**Re:** Hasheider Subdivision - final minor plat/replat (Case #15-161)

# AGENDA REPORT PLANNING AND ZONING COMMISSION MEETING August 6, 2015

# 15-161: Hasheider Subdivision Final Minor Plat

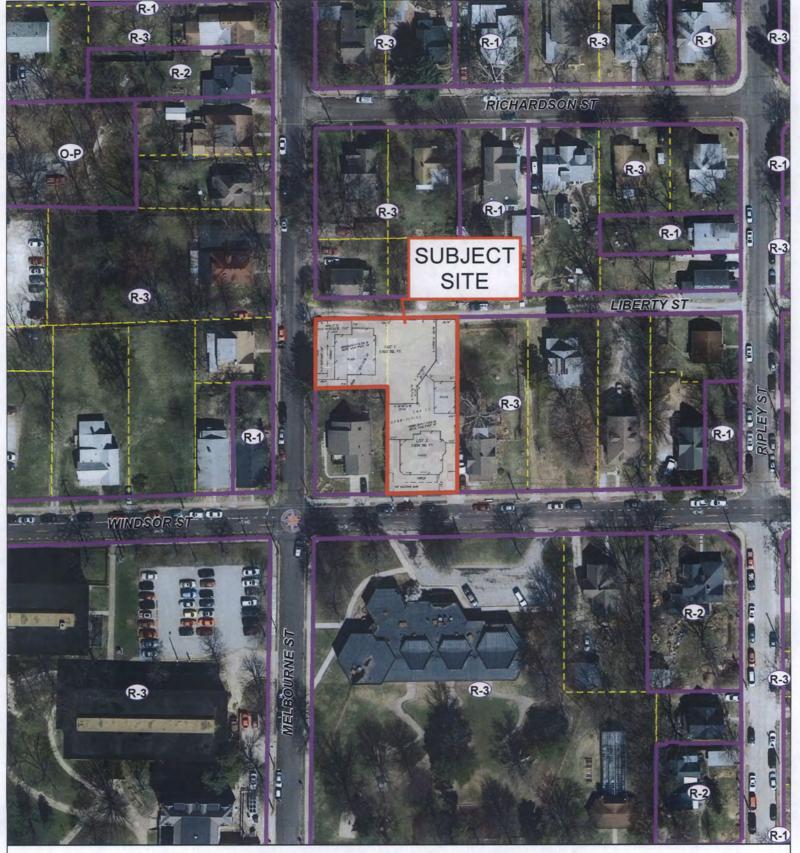
The front porch of # 204 Melbourne Street is only 10.5 feet from the property line. The lot rises approximately 3 feet from the curb to the bottom of the porch. In order to construct the required 5 foot wide sidewalk, it would be necessary to remove the existing walkway to the porch, remove an existing concrete wall along the south side of the alley and perform considerable grading. This would also require construction of retaining walls along the front of the house and the removal of a large, 18 inch diameter pine tree. This is a quiet, residential street with a complete sidewalk system along the west side and this 65 foot long section of sidewalk is not needed.
